LEHIGH RIVER BASIN  
POHOPOCO CREEK, PENNSYLVANIA  
**BELTZVILLE LAKE**

CONDITION REPORT

DAM, OUTLET WORKS & SPILLWAY,  
PERIODIC INSPECTION REPORTS NO. 3 & NO. 4,  
SEPTEMBER 1972 & AUGUST 1973

SUBJECT: Peltzville Lake, Periodic Inspection Report Number 3 & 4.

LEHIGH RIVER BASIN  
POHOPOCO CREEK, PENNSYLVANIA  
BELTZVILLE DAM & RESERVOIR  
WEIR DISCHARGE

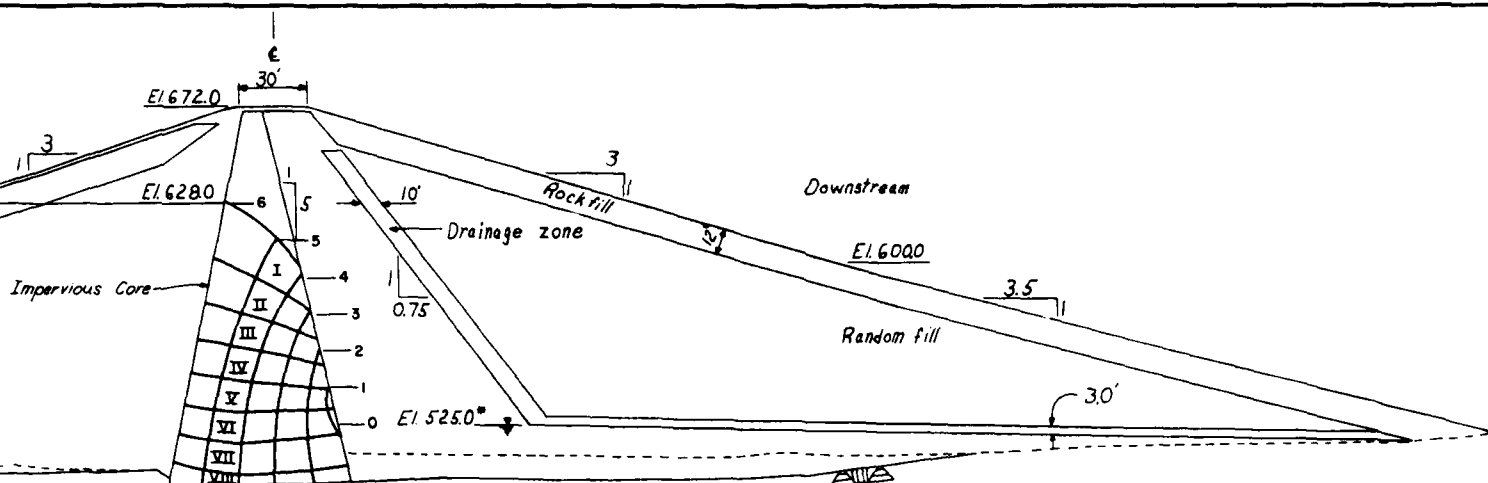
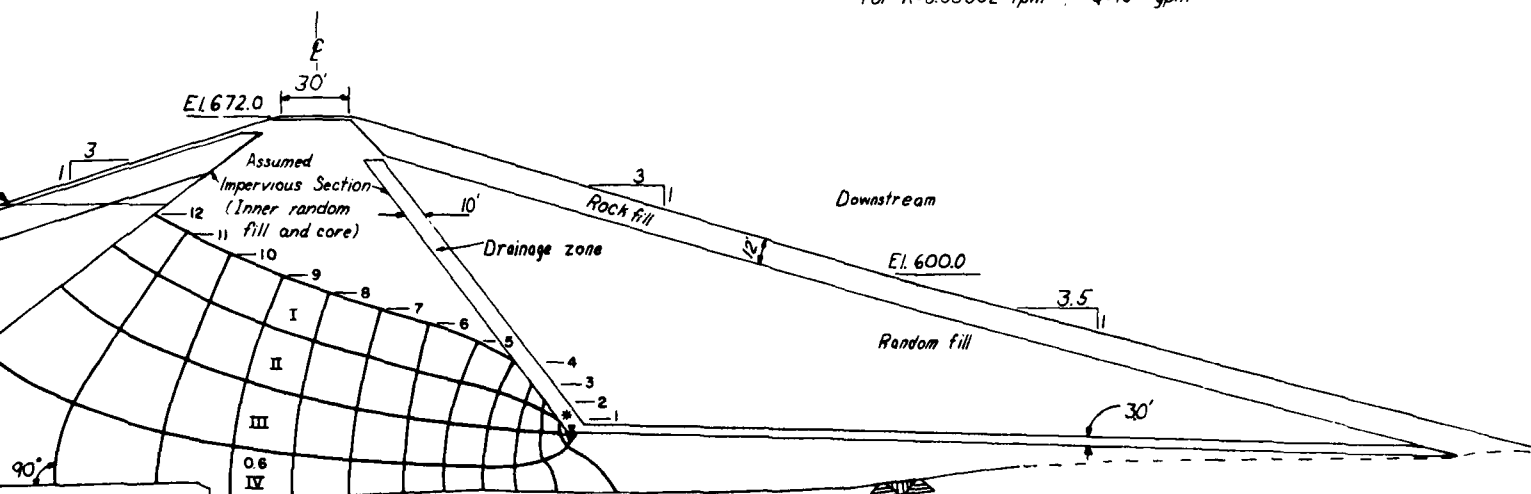
Evaluation. The weir readings and stabilization of the base flow after reaching full pool show that the seepage is, to the present, a small and controlled discharge which, from embankment seepage computations and other indications, originates primarily from the rock foundation. Since the flow is small and stabilized and there is no visual or instrumental evidence of any harmful effects, the seepage is not considered to represent any serious problem. Monitoring of the weir flows will continue.
